SERVICE INFORMATION BULLETIN

Subject:
CORRECTION IN WORKSHOP MANUAL FOR TIGHTENING TORQUE OF THE INJECTOR CLAMP BOLT

FUEL SYSTEM (J05D)

EN07-3

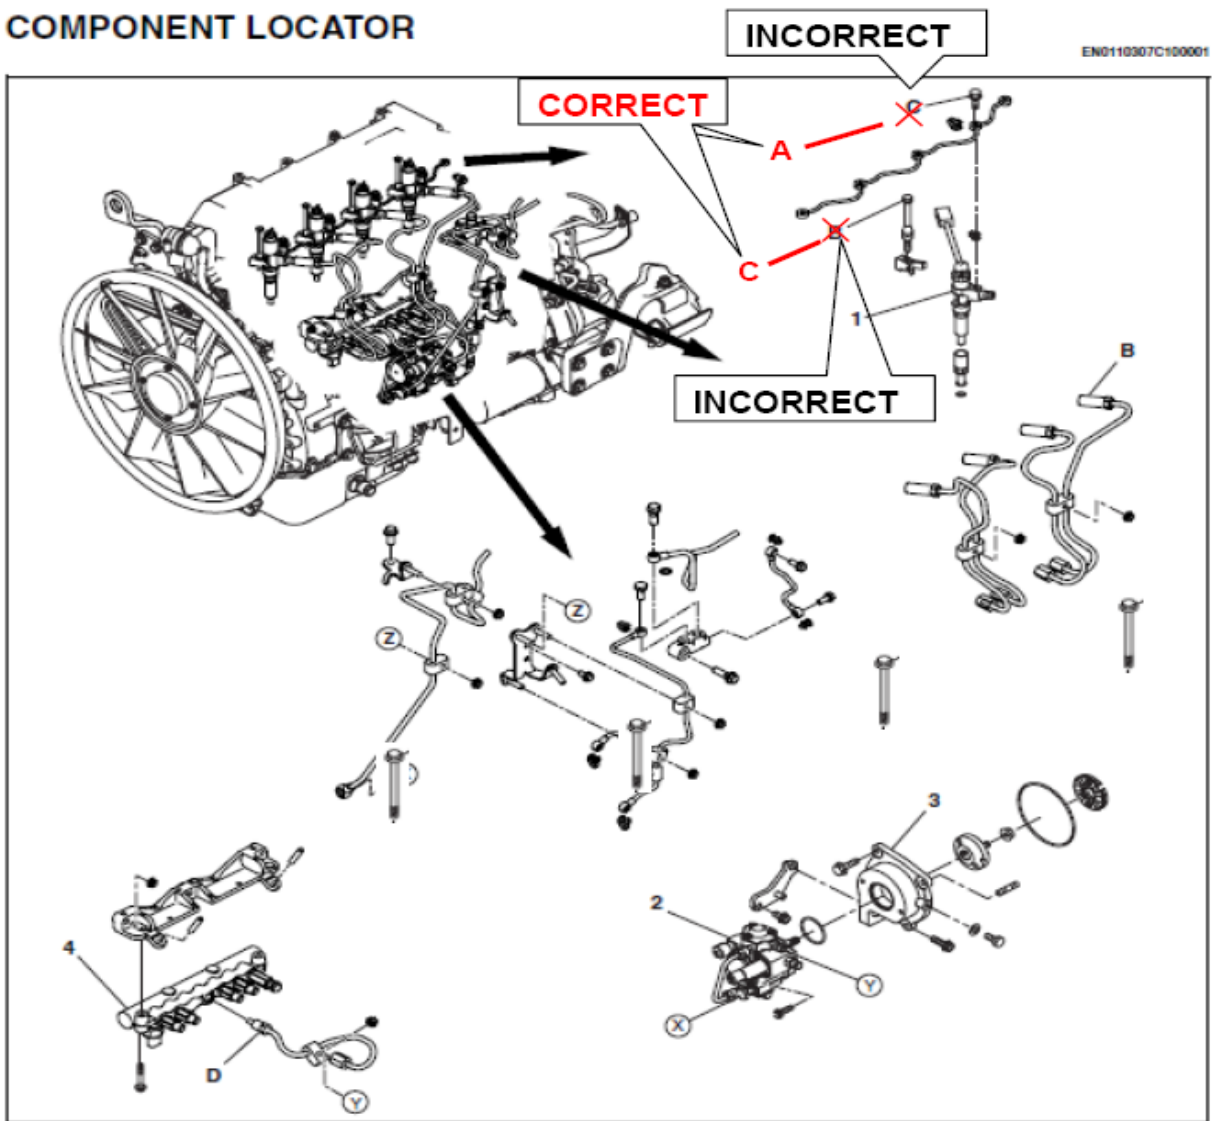
The tables in the respective manuals and pages shown above are incorrect. Please replace the incorrect tables.

Tightening torque Unit: N·m {kgf·cm, lbf·ft}

A 12.3 {126, 9}	C 26 {250, 18}
B 39.2-49 {400-499, 29-36}	D 49-58.8 {500-599, 37-43}
